Access Compliance Report Public Rights-of-Way (Curb Ramps)

Main Street: PICKERING_CIR		Cross Street: MINFORD_RD		Location:	W
ADA ID: RPRK211108124036	Ramp Type: Type 4 - Parallel	Initial Pass/Fail: Fail	Overall Compliance: No	Severity Score:	32
Codes/Mitigation Info/Possible Solution			Field Measurements/Component Compliance

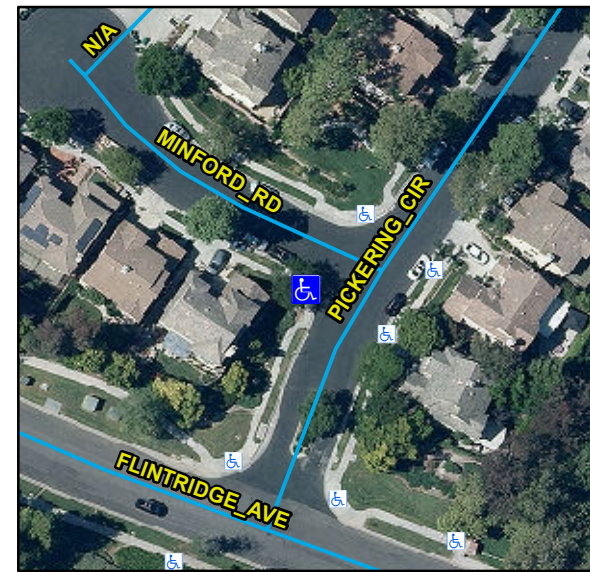
Compliance	Description	Data	Compliance	Description	Data
N/A	Ramp Length LT (in)	107	N/A	Ramp Length RT (in)	106
Yes	Ramp Width LT (in)	54	Yes	Ramp Width RT (in)	54
Yes	Ramp Run Slope LT (%)	1.7	No	Ramp Run Slope RT (%)	16.6
No	Ramp Cross Slope LT (%)	2.3	No	Ramp Cross Slope RT (%)	2.1
N/A	Landing Present	N/A	N/A	DWS Provided	N/A
N/A	Landing Length (in)	N/A	N/A	DWS Contrast	N/A
N/A	Landing Width (in)	N/A	N/A	DWS Length (in)	N/A
N/A	Landing Run Slope (%)	N/A	N/A	DWS Full Width	N/A
N/A	Landing Cross Slope (%)	N/A		DWS Offset Type	N/A
N/A	Landing Movement Obstructed?	N/A	N/A	DWS Offset Left (in)	N/A
	Landing Movement Type	N/A	N/A	DWS Offset Right (in)	N/A
N/A	Landing Shared	N/A			
N/A	Clear Space	Yes			
N/A	Clear Space To Crosswalk (in)	N/A			
N/A	Marked Crosswalk 1	No	N/A	Marked Crosswalk 2	No
	Crossing 1 Direction	SE		Crossing 2 Direction	NE
N/A	Marked Crosswalk 1 Width (in)	N/A		Marked Crosswalk 2 Width (in)	N/A

Remove & Replace Curb Ramp With Two New Directional Ramps or Equivalent.
